# Product Support Bulletin 2010-013

## Maintenance of Way ~ Work Equipment Bulletin

**SUBJECT:** Inspect for Possible Main Frame Cracks

**MACHINE MODEL(S):** TRIPP – Tie Exchanger

**Figure 1**  
Crack in vertical plate of TRIPP Tie Extractor

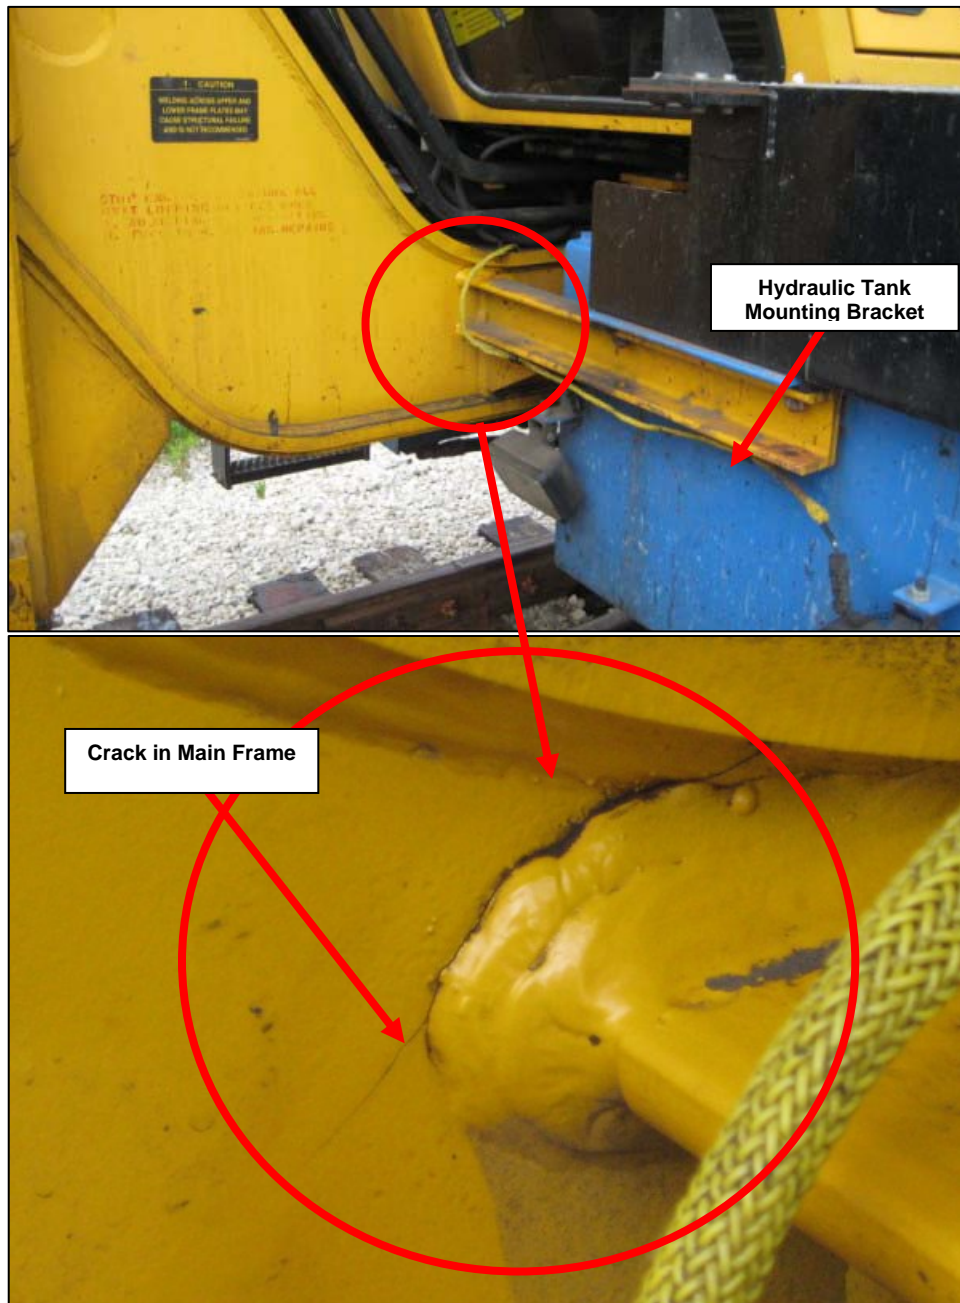
**SUMMARY:** Cracks in the Main Frame of the TRIPP Tie Exchanger have been discovered. The cracks originate in the weld beads connecting the top and side plates of the main frame in the area of the hydraulic tank mounting channel. See Figure 1 on Page 2. It has been determined that the cracks are caused by the ending and restarting of the weld beads in an area of high stress.

**OPERATIONAL IMPACT:** The frame cracks discovered have been hairline. If not properly repaired, the cracks can extend through the entire thickness of the side plate.

**ACTION:** **All machines MUST be inspected for cracks in the area shown in Figure 1 on Page 2.** If cracks are discovered, **DO NOT ATTEMPT TO RE-WELD THE CRACK.** Repairs must be done using a recommended process authorized by the Nordco Engineering Department. Contact the Nordco Service Department to arrange for warranty repairs. Only repairs authorized or performed by Nordco will be covered under warranty by Nordco. Please see the WARRANTY section for details.

**WARRANTY:** Any machine with frame cracks as shown in Figure 1 on this page will be repaired under warranty. Contact the Nordco Service Department at 800-445-9258 to arrange for repairs to be made.
